Sustainable Communities Environmental Assessment Errata

5001 Wilshire Project

Case Number: ENV-2021-3327-SCEA
DIR-2021-3324-CLQ, DIR-2021-3326-TOC-SPR-VHCA, VTT-83358

August 2022

FIGURE II-18

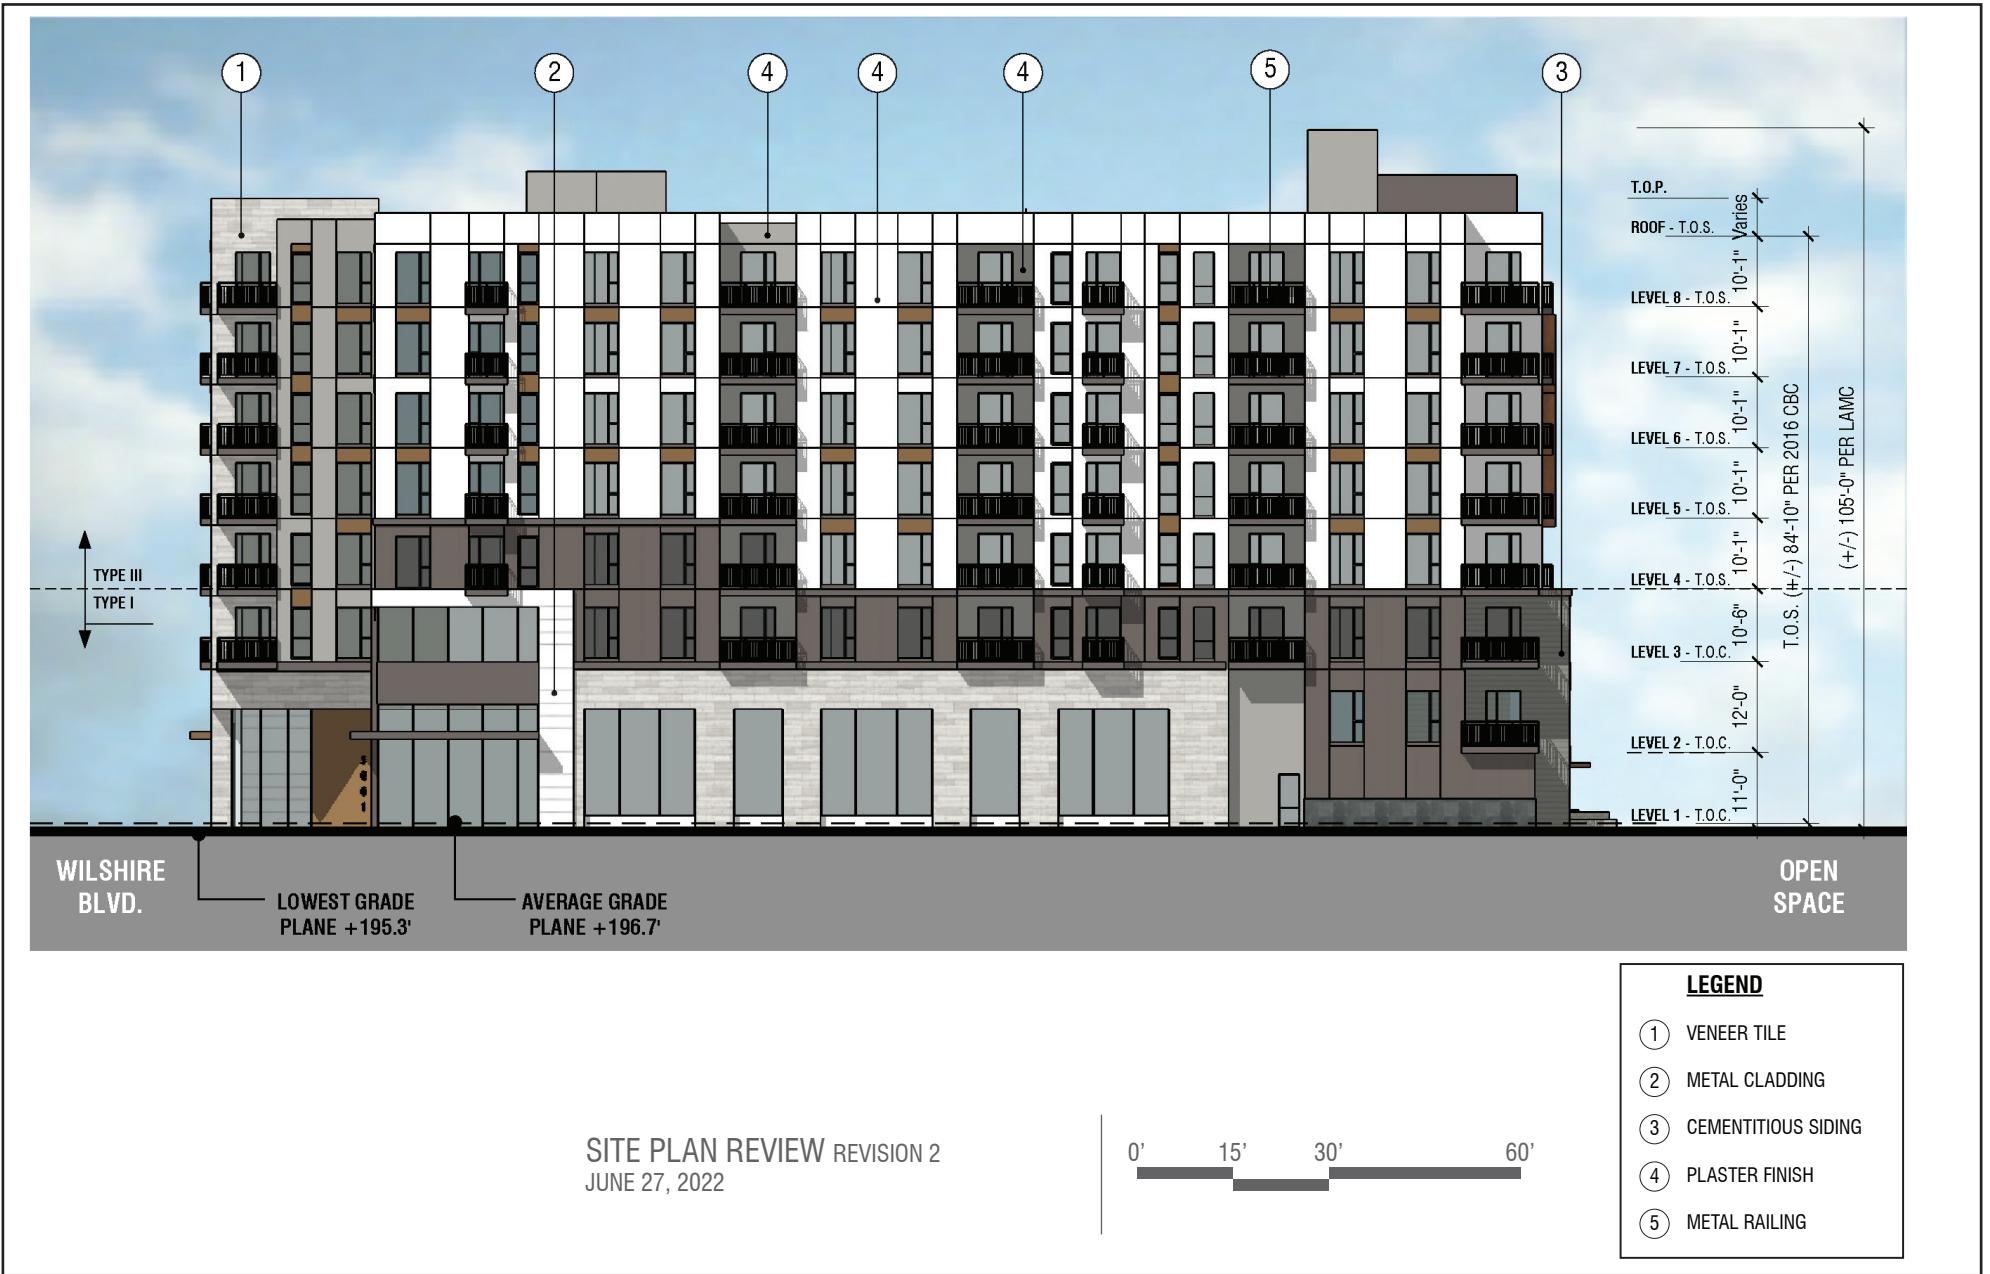
Figure II-18 South Elevation - this figure reflects minor updates made to the building exterior and demonstrates that the updates made to the subterranean and above-grade parking do not cause any changes to the building's exterior.

FIGURE II-19

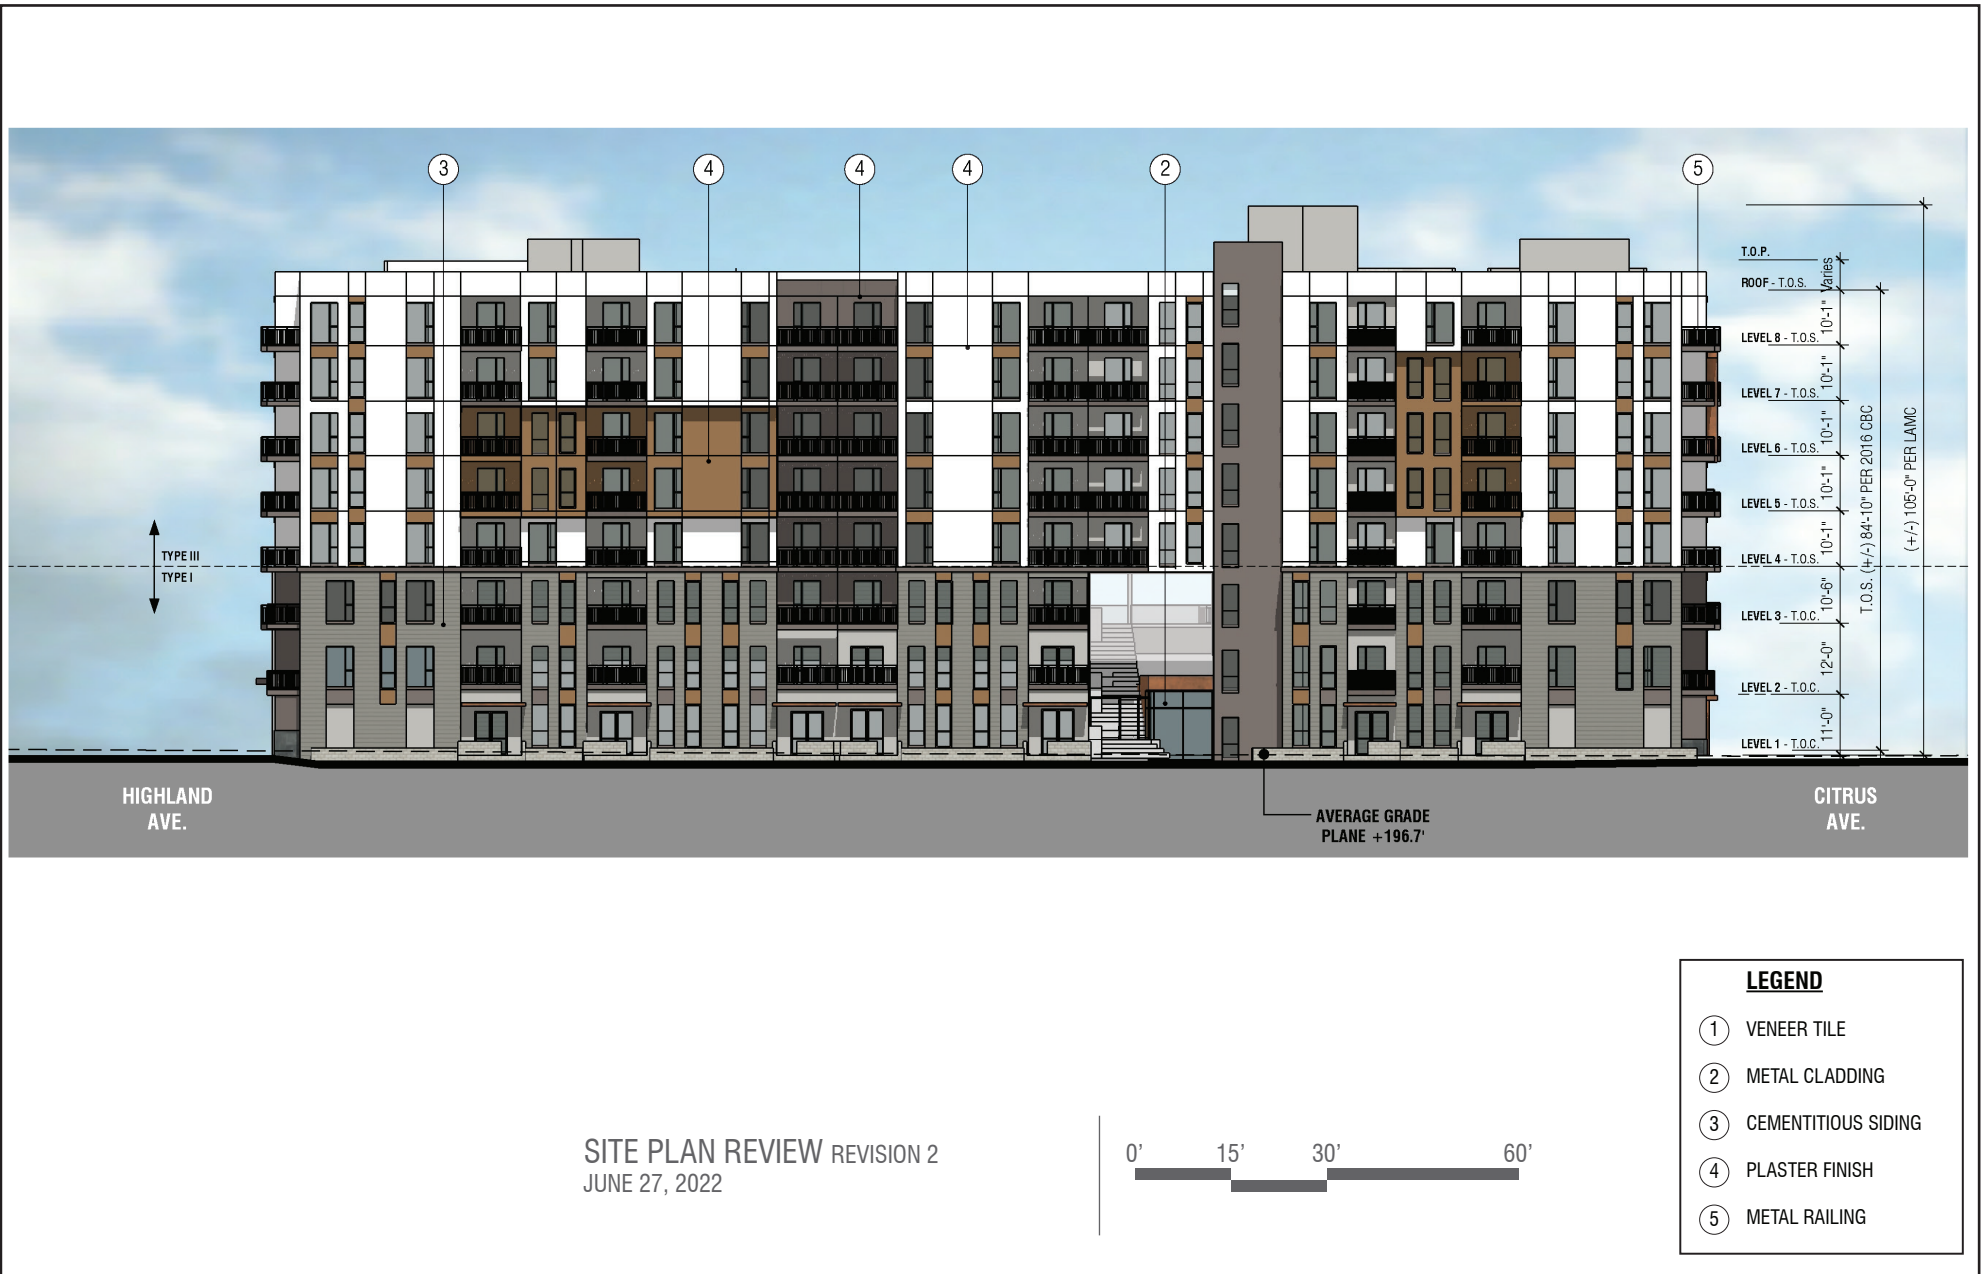
Figure II-19 West Elevation - this figure reflects minor updates made to the building exterior and demonstrates that the updates made to the subterranean and above-grade parking do not cause any changes to the building's exterior.

FIGURE II-20

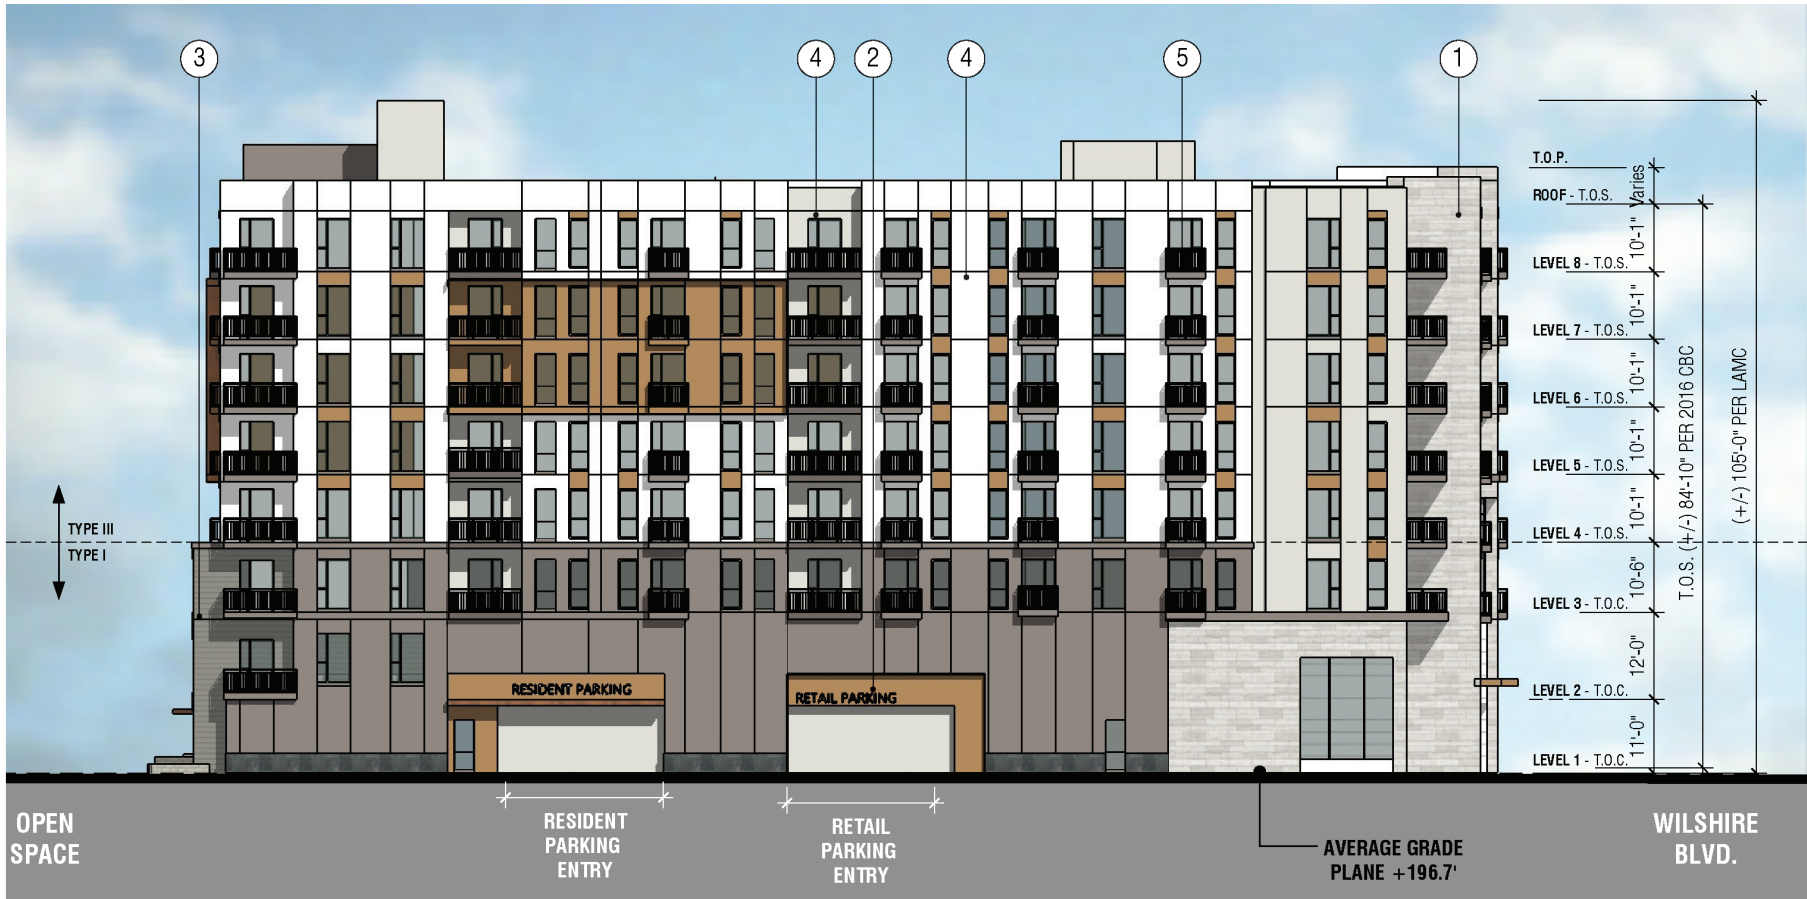
Figure II-20 North Elevation - this figure reflects minor updates made to the building exterior and demonstrates that the updates made to the subterranean and above-grade parking do not cause any changes to the building's exterior.

FIGURE II-21

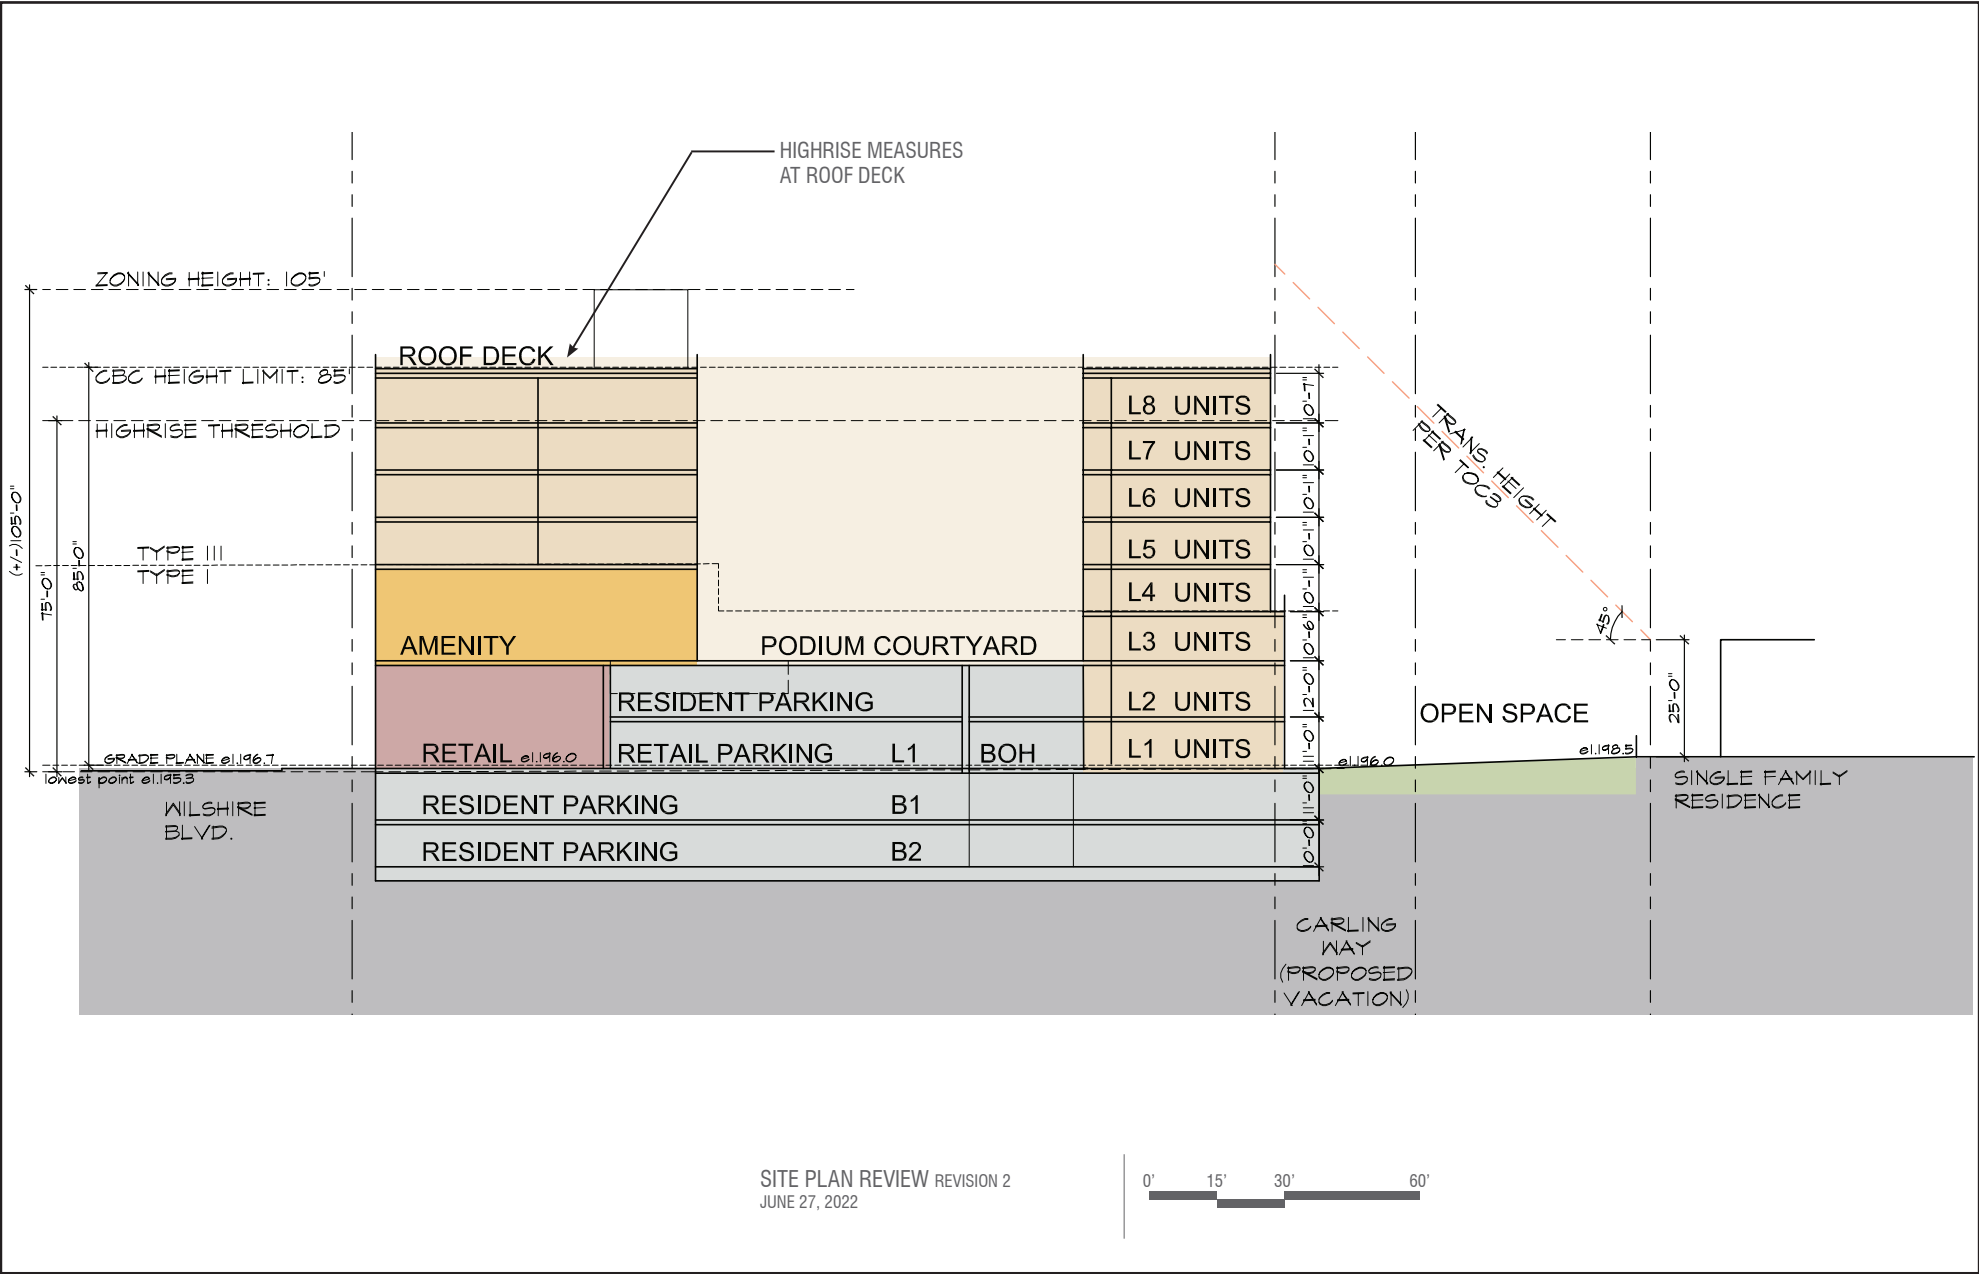
Figure II-21 East Elevation - this figure reflects minor updates made to the building exterior and demonstrates that the updates made to the subterranean and above-grade parking do not cause any changes to the building's exterior.
